first place

Design Review Presentation - April 6, 2011

Improved Design Incorporating Early Design Guidance Recommendations

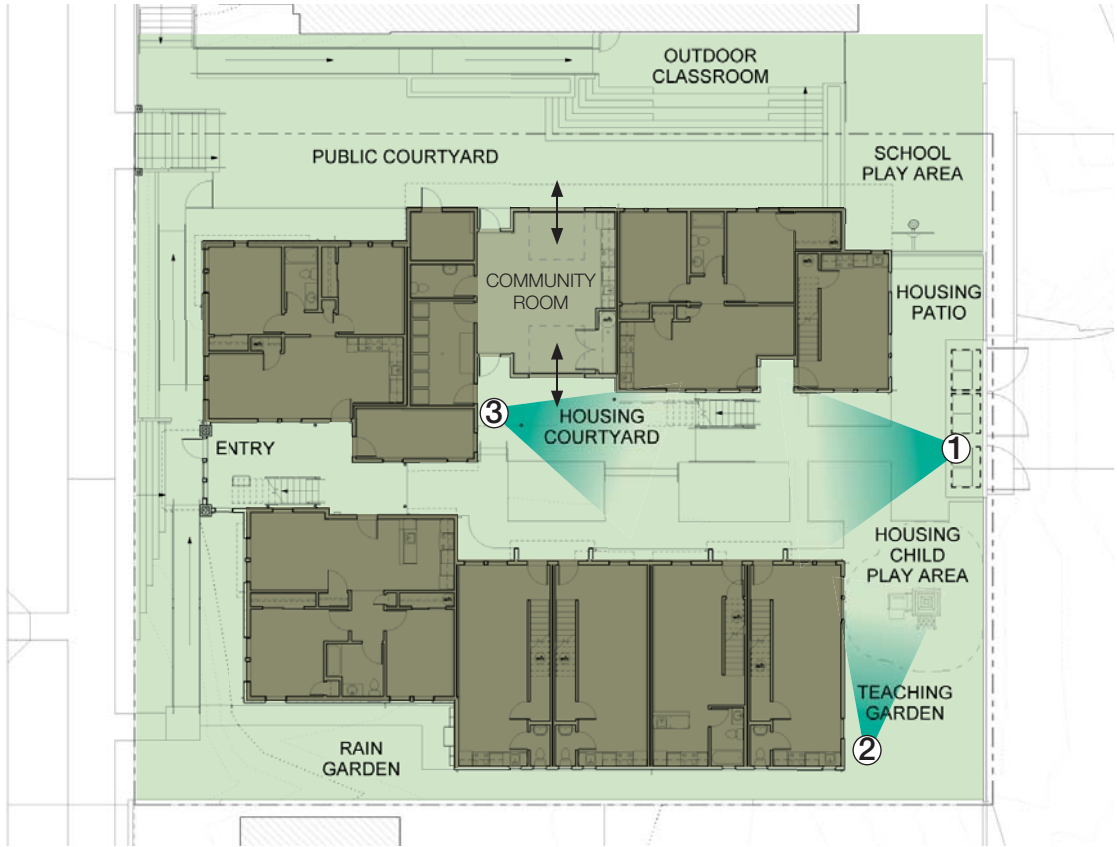
In addition to the comments in response to Guideline A-2, the Board directed the applicant to carefully design the separation between the two buildings, where that separation will be visible from the street front. This design should unify the two buildings and enhance the street facing façade. Possible solutions could include a wall connecting the two buildings, the stairs as an architectural expression, or a green wall.

DKA response
New entry now unifies the two residential bar buildings and enhances the street facade and presence.

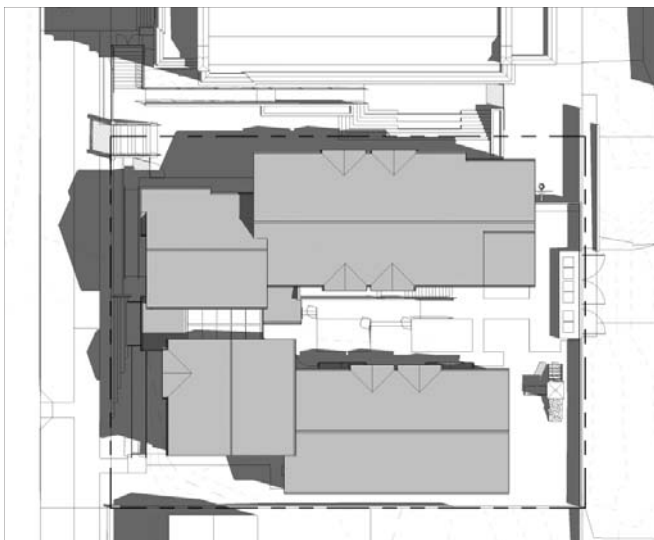
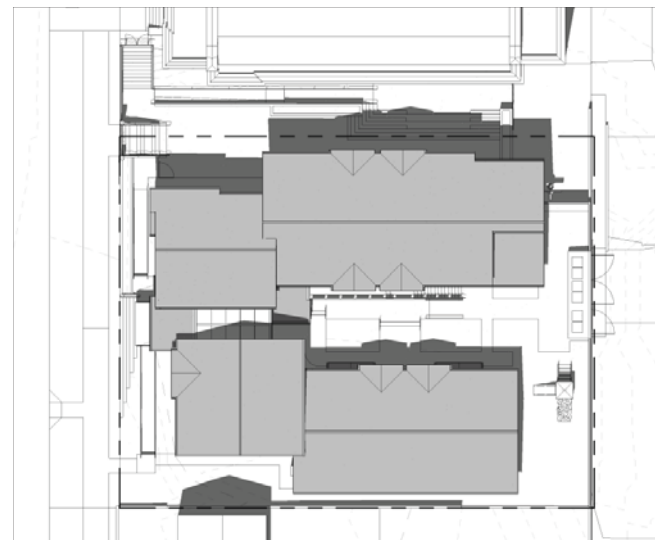
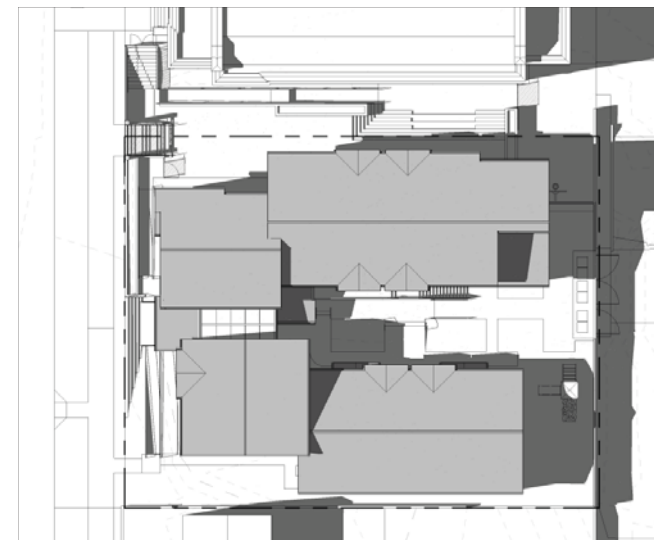
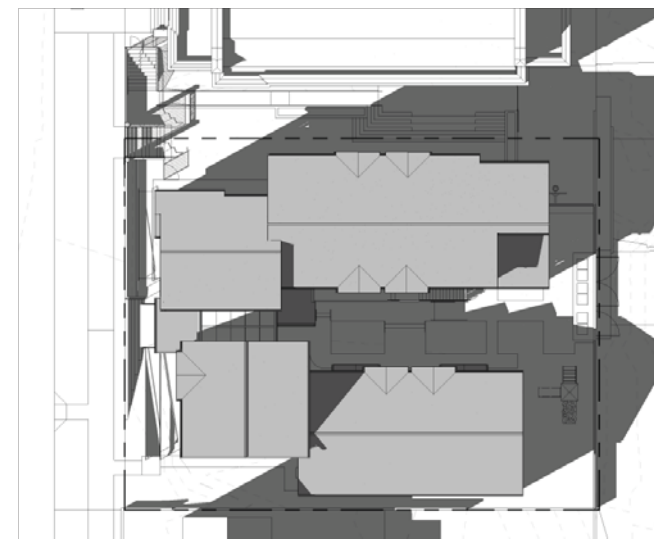
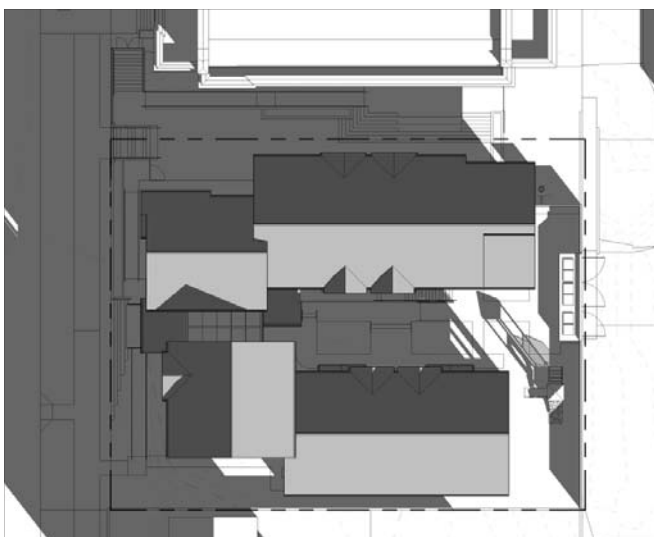
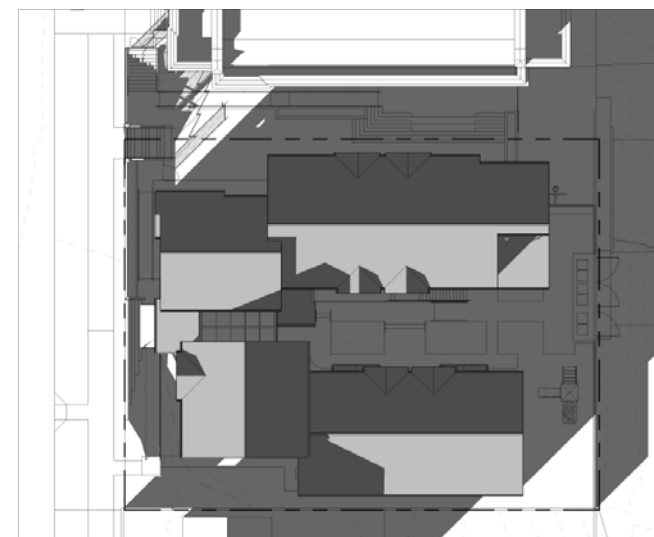
The Board was concerned with the character of the space between the two buildings. This space requires careful design to maximize light and air, visually integrate the external stair and walkways, and create human scale in the interior building facades. The applicant should provide shadow studies, floor plans demonstrating the relationship of units to the courtyard, and interior elevation drawings at the Recommendation stage of review.

DKA response
Relationship of units to the courtyard has been enhanced and articulated in the building facades, creating a more well-developed housing courtyard and entry sequence from street. Interior elevations articulate entries for individual units.

Shadows are included as required for the MUP set. Shadow studies are included on this page of this package.

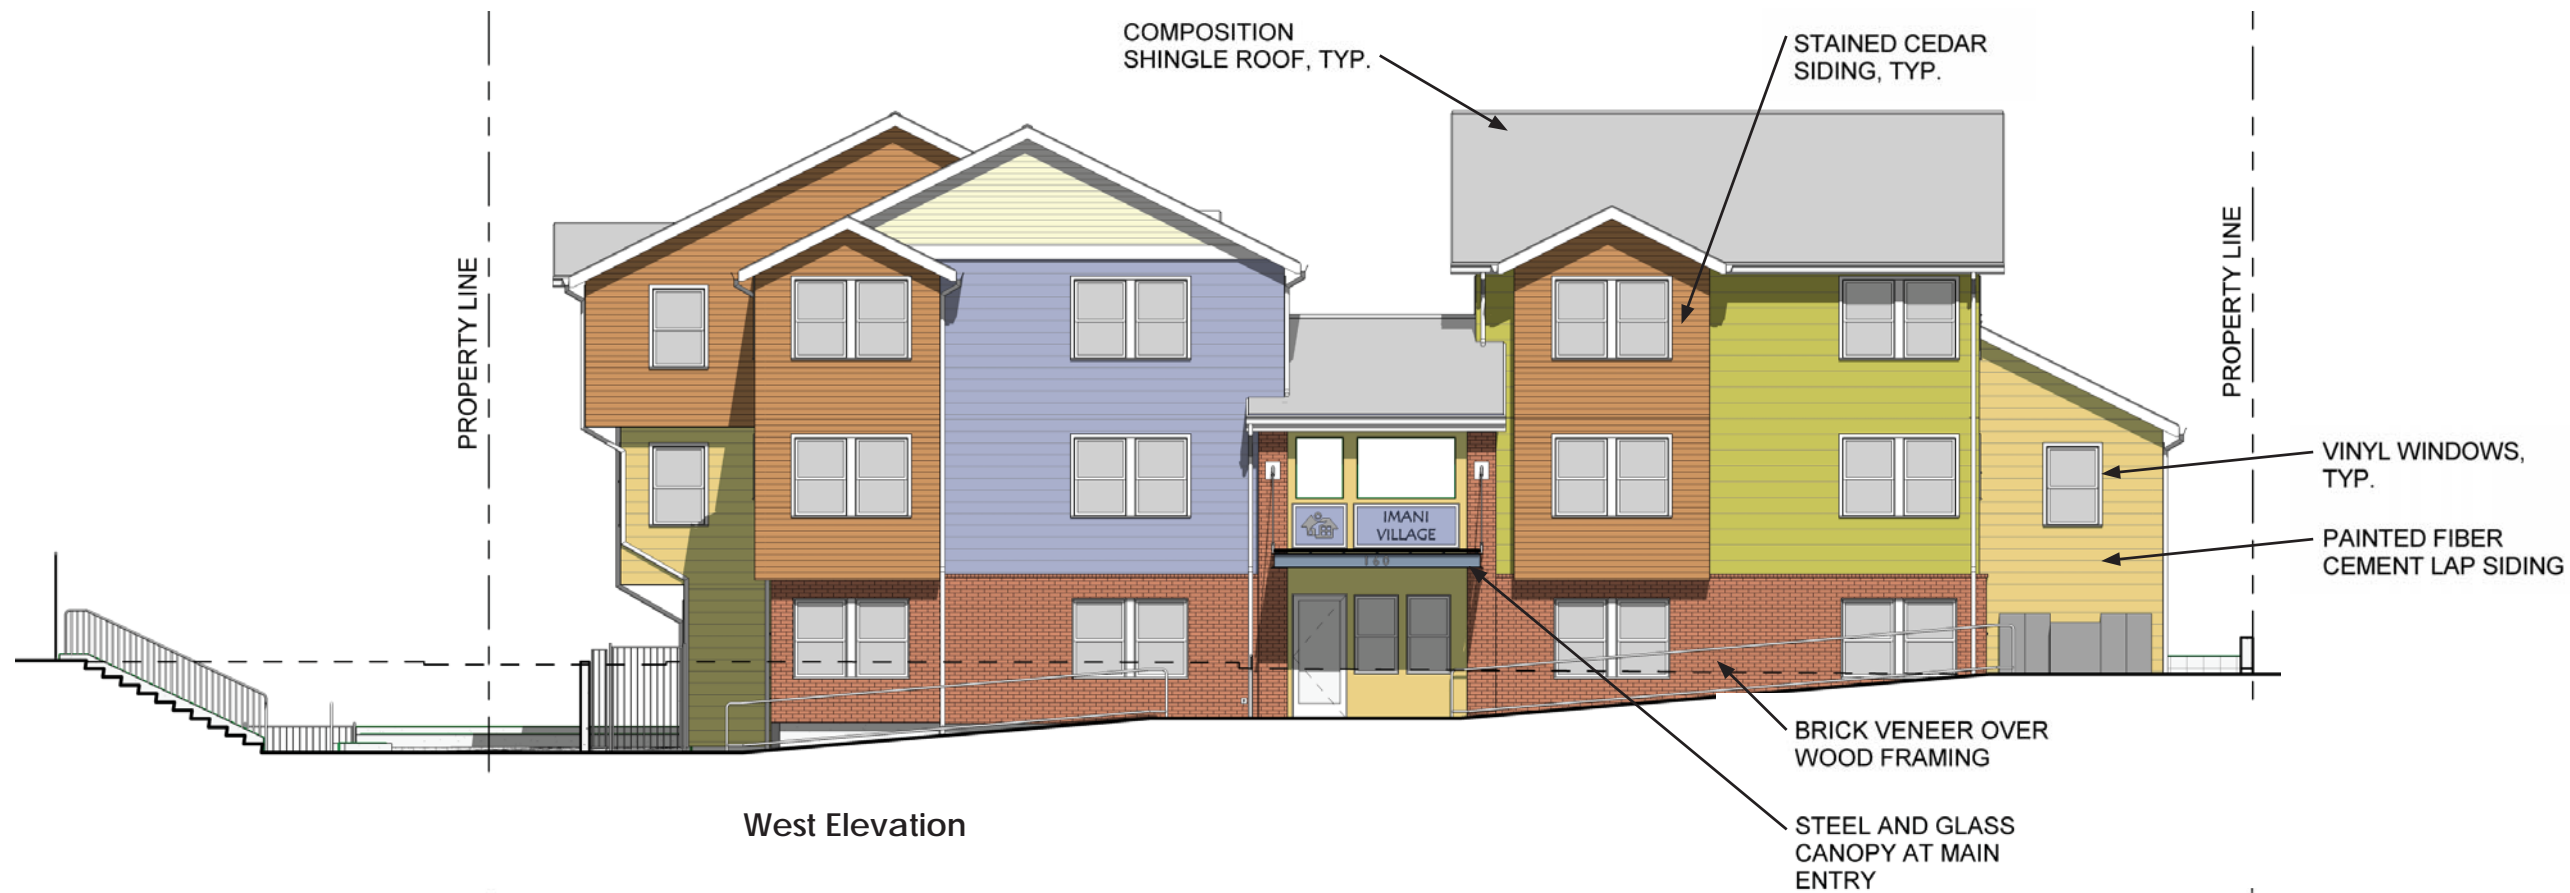
Comments reflect those in response to Guideline A-1, A-2, A-6, and A-7.

DKA response
The building design has been further developed to include window size, trim, guardrail, entry and second story walkways that provide an appropriate sense of human scale.

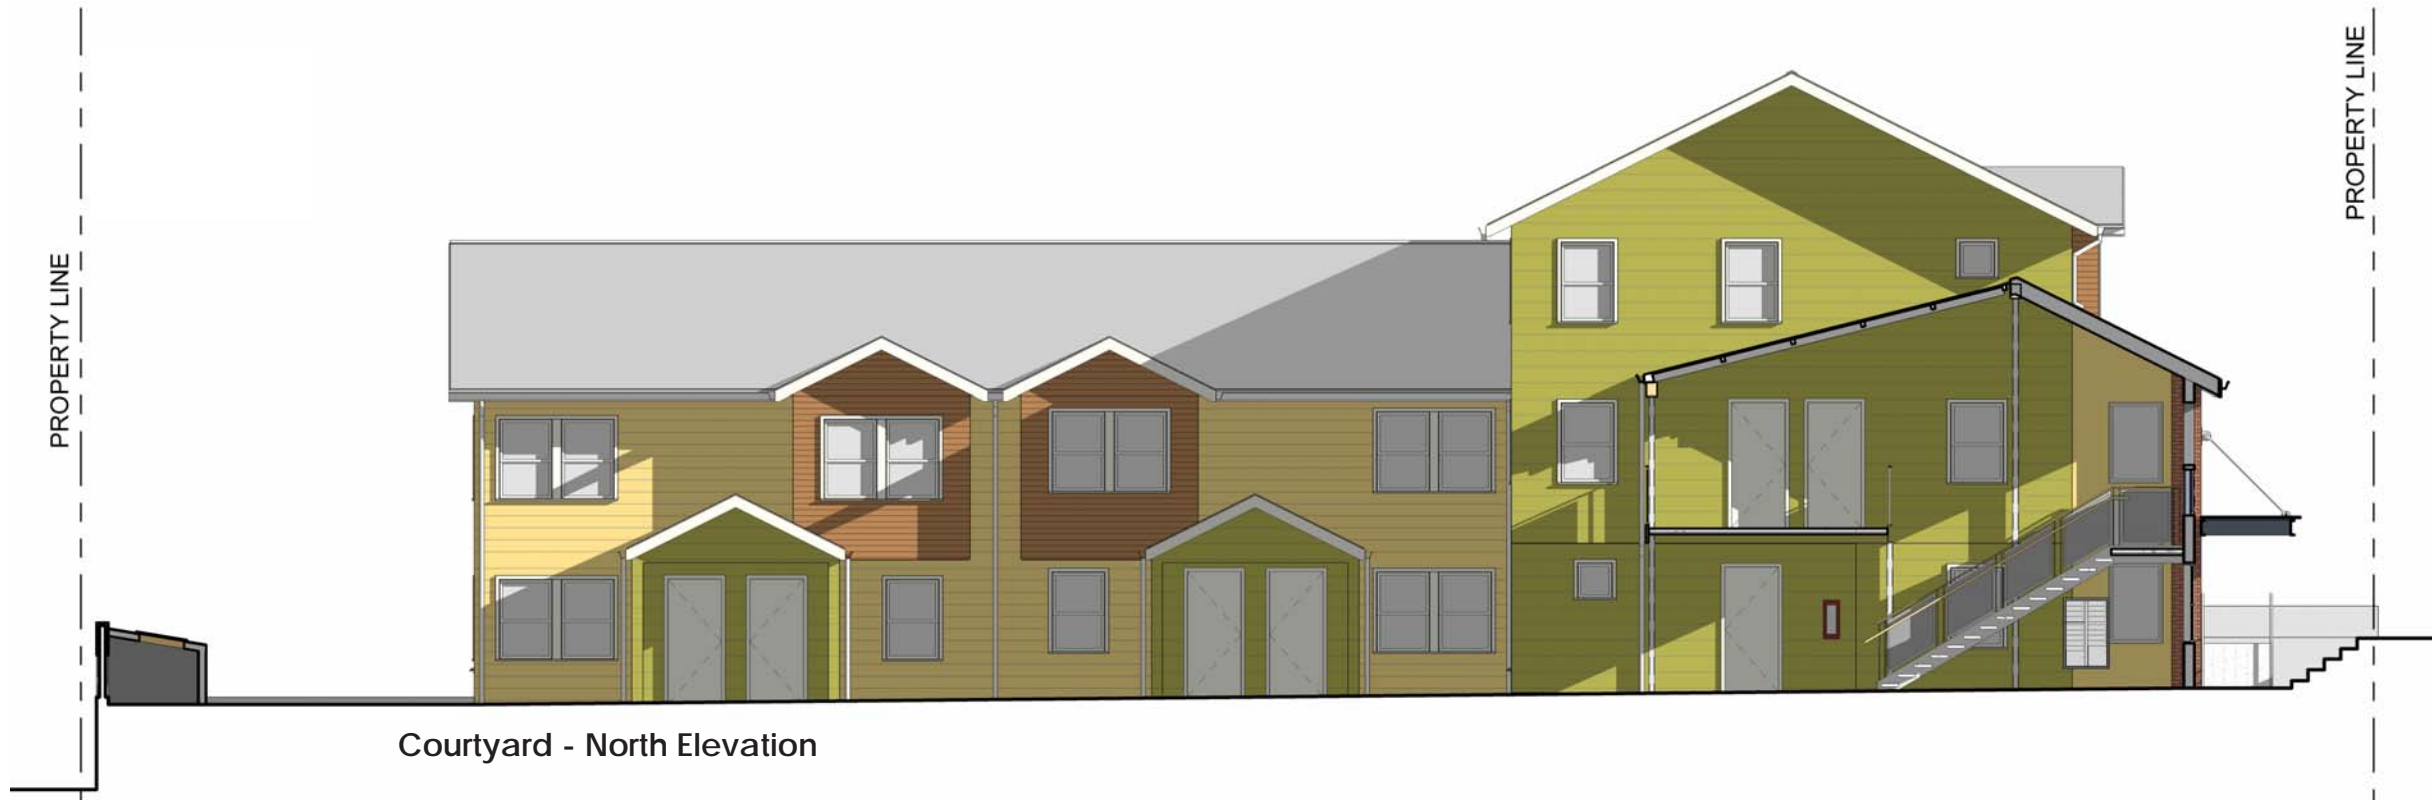
Comments reflect those in response to Guideline A-1, A-2, A-6, and A-7.

DKA response
Exterior elevations are a combination of Hardiplank horizontal lap siding, brick at the ground floor and recycled wood at projected window bays. All materials are treated with residential scale tectonic detailing.
